A G E N D A

Architectural Review Board

March 1, 2016

655 Hubbard Street

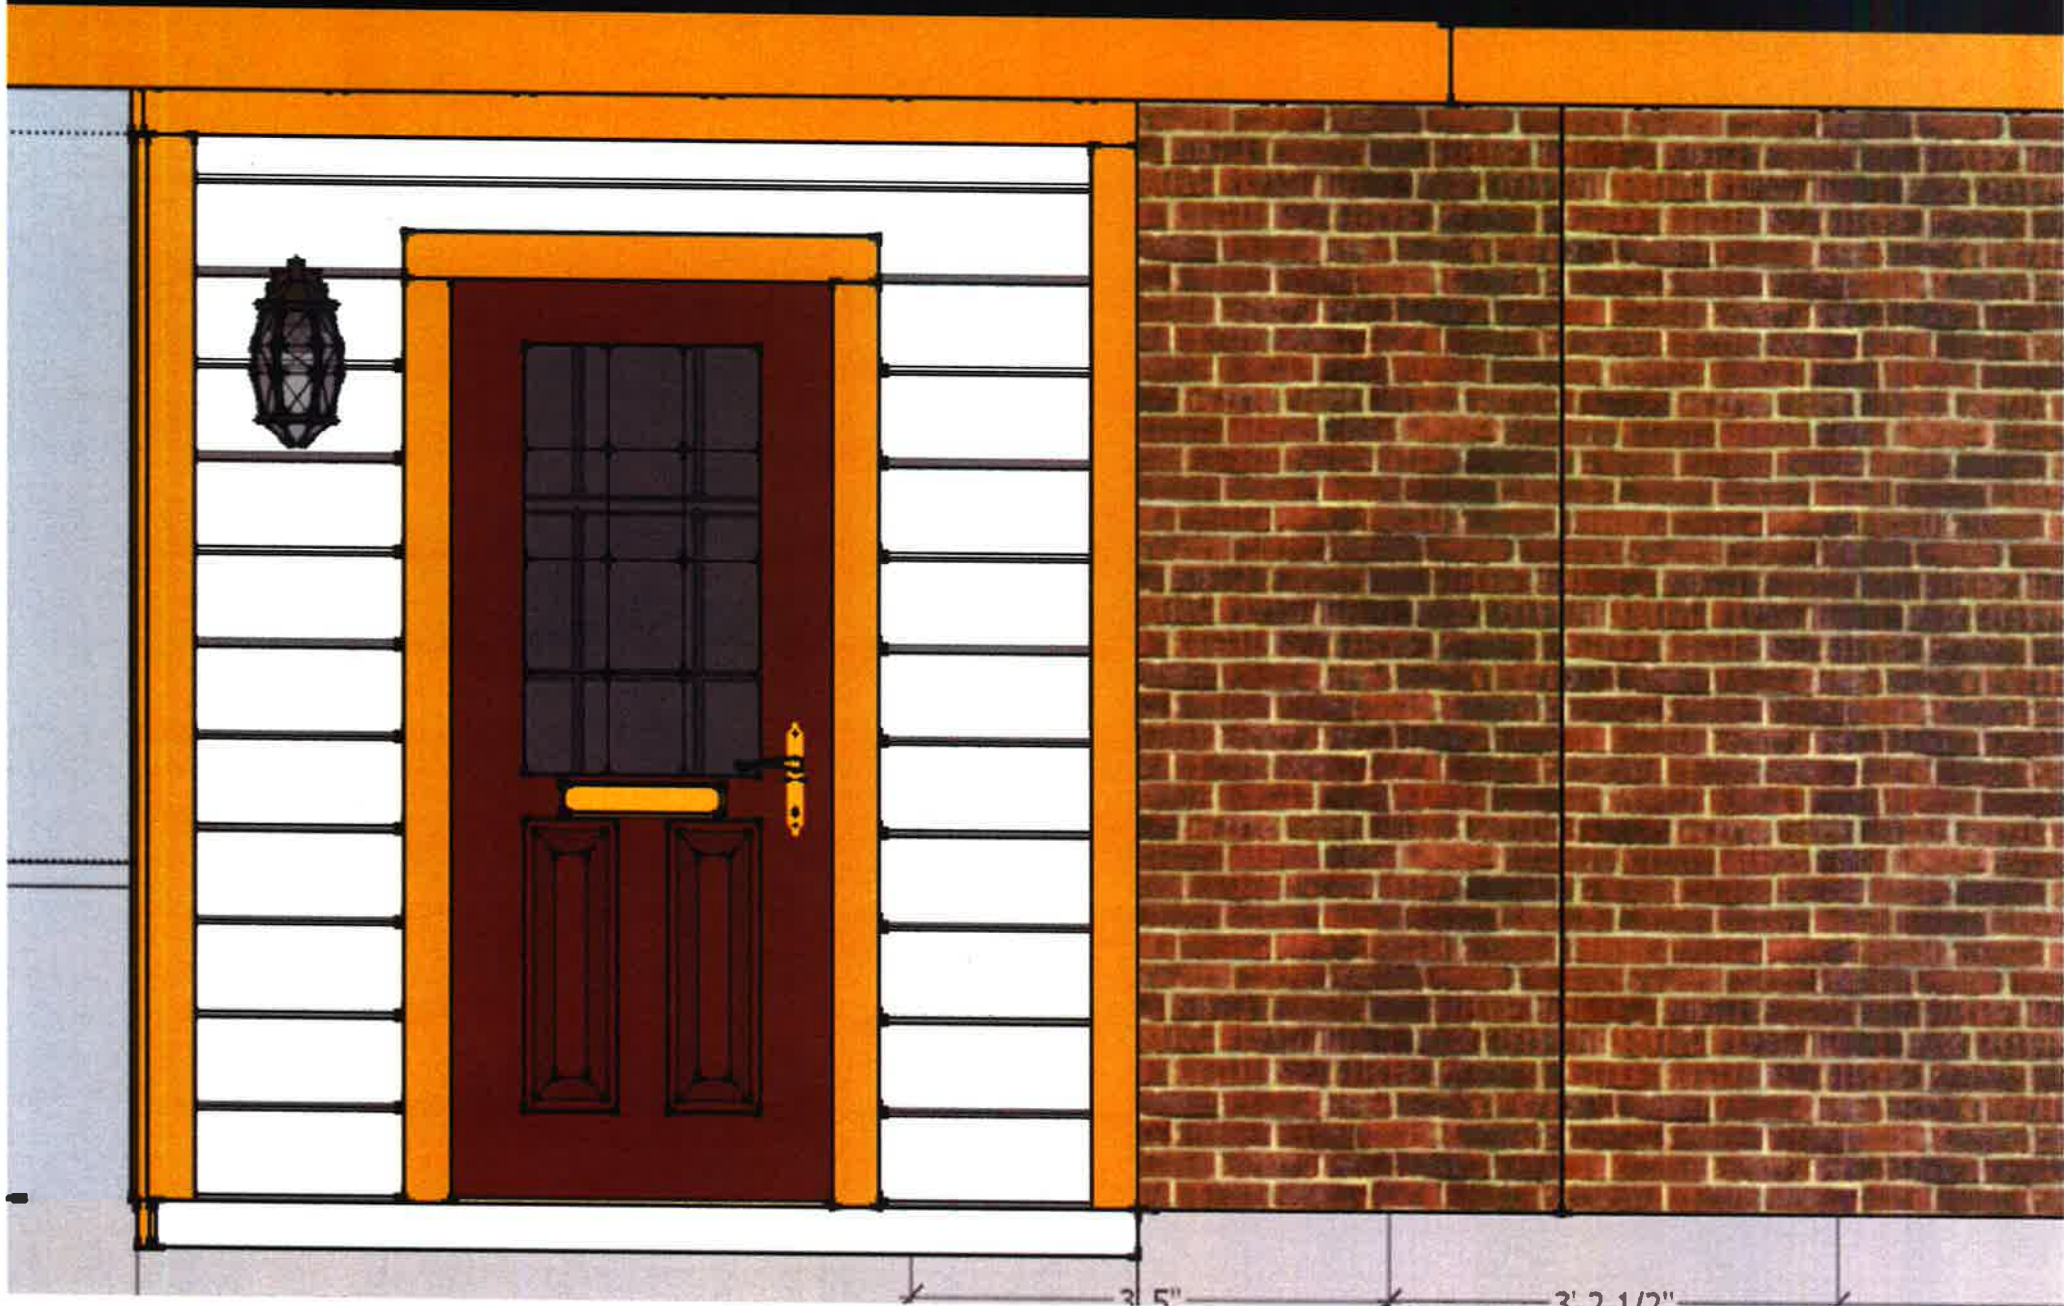
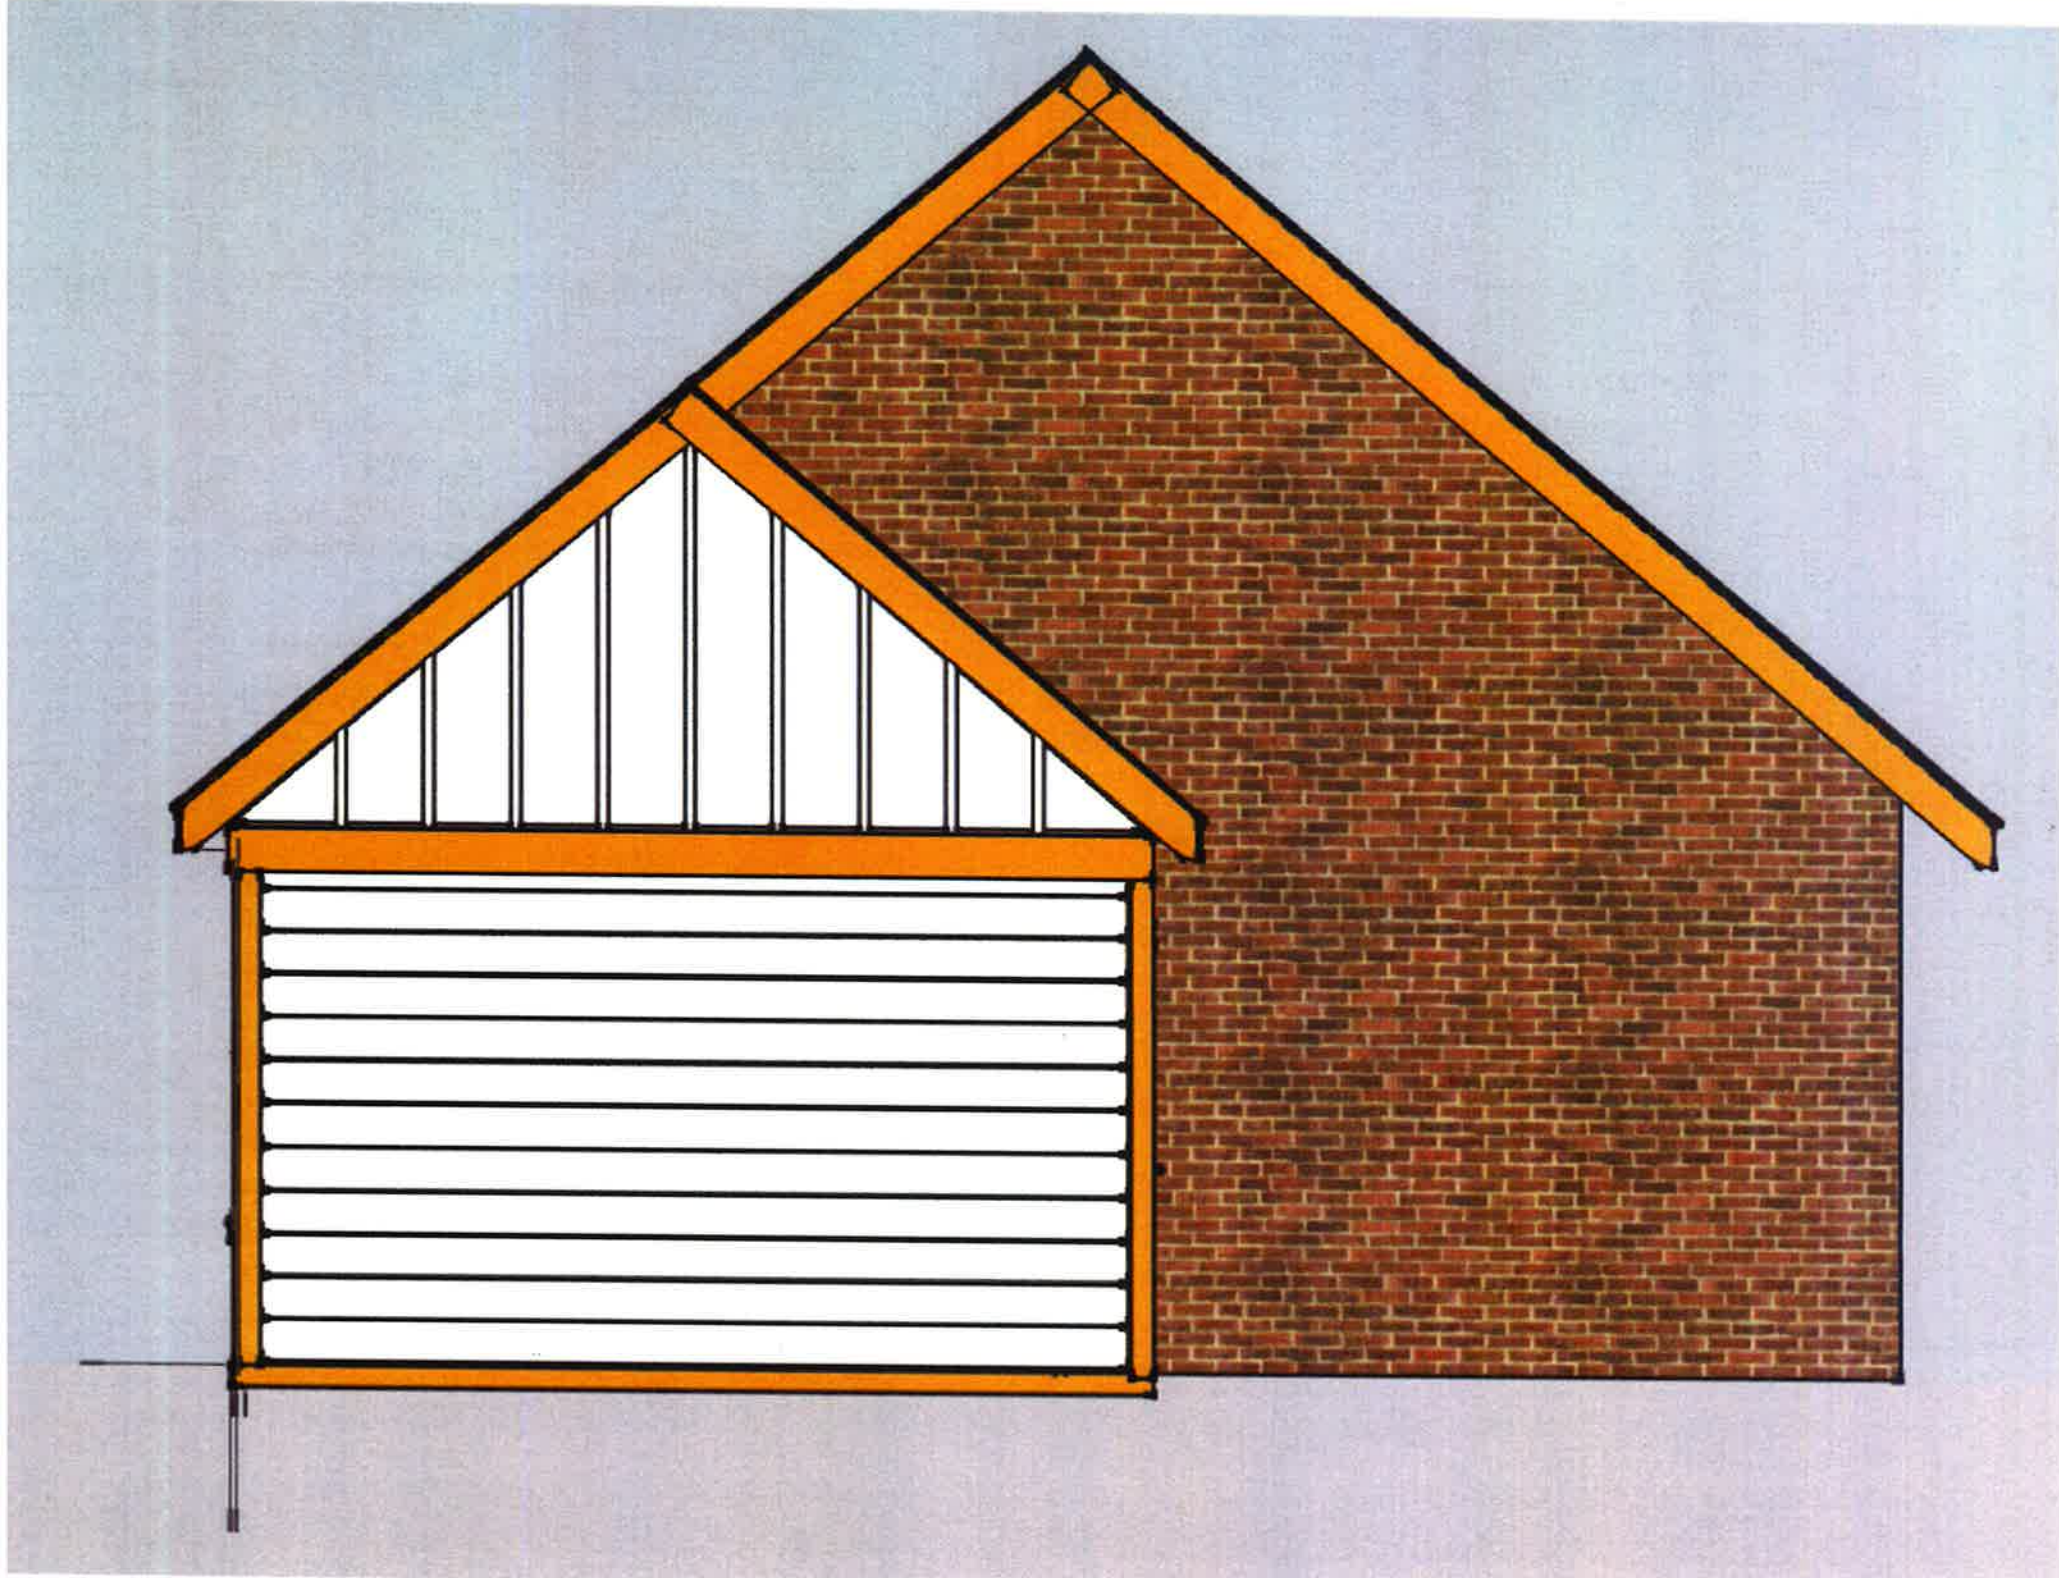
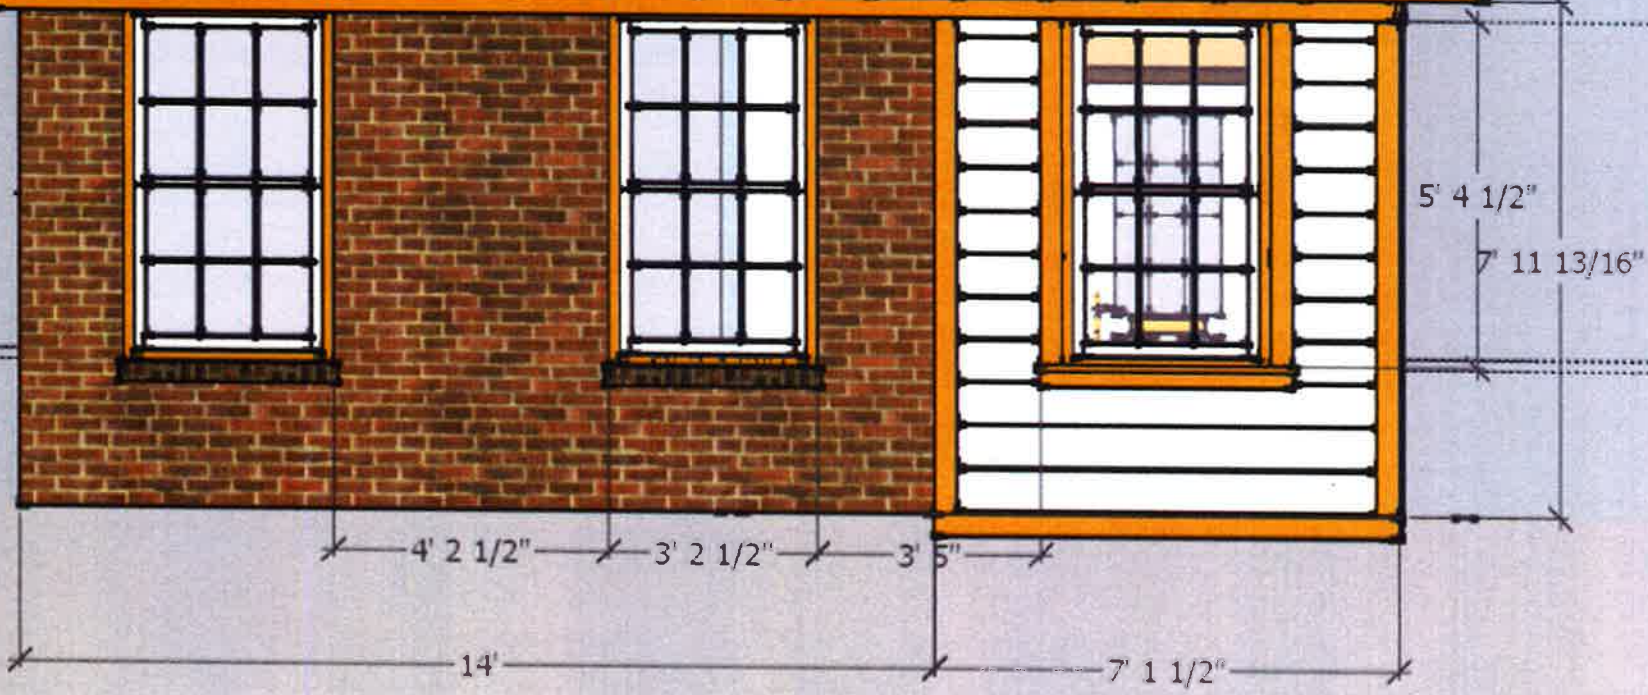
- The Board has previously approved the enclosure of side porches that have been set back from the front plane of the house.
- The Board denied the enclosure of a side/front porch where the porch made up half of the front elevation.
